**DEFENSE NUCLEAR FACILITIES
SAFETY BOARD**

October 17, 2018

Pantex Plant Special Tooling Program Review

Figure 1. *Cracked Safety Catches in the W76 Aft Disassembly Fixture, 076-2-0382 [26].*

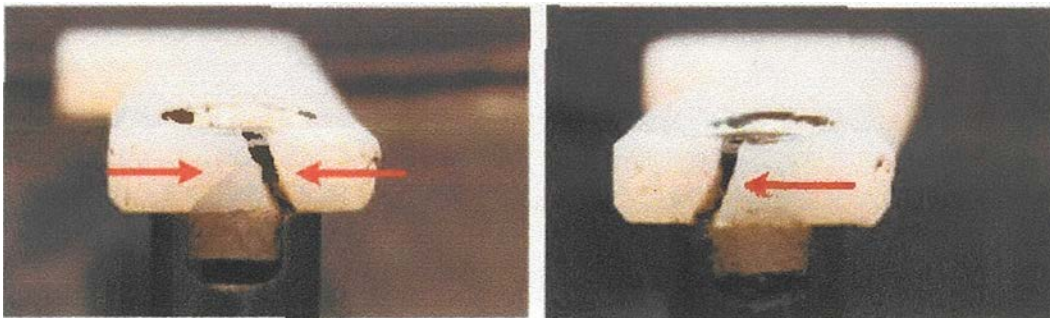
- *Safety Catches*—The staff review team evaluated the use of W76 vacuum lifting fixtures and the 2015 issue in which cracks were identified in vacuum lifting fixture safety catches (see Figure 1). The safety catches are a secondary feature to prevent a drop of high explosive charges should vacuum fail on the lifting fixture. The staff review team is concerned that actions taken to-date may not prevent recurrence of cracking of safety catches. Pantex continues to rely on production technicians to identify cracking during routine prior-to-use inspections. The staff review team believes that application of an ISI or introduction of a specific step within the nuclear explosive operating procedure to check for safety catch damage prior to use would bolster the reliability of this check. Alternatively, the safety catches could be redesigned, substituting a material with a lower likelihood of cracking (e.g., appropriately coated metal).
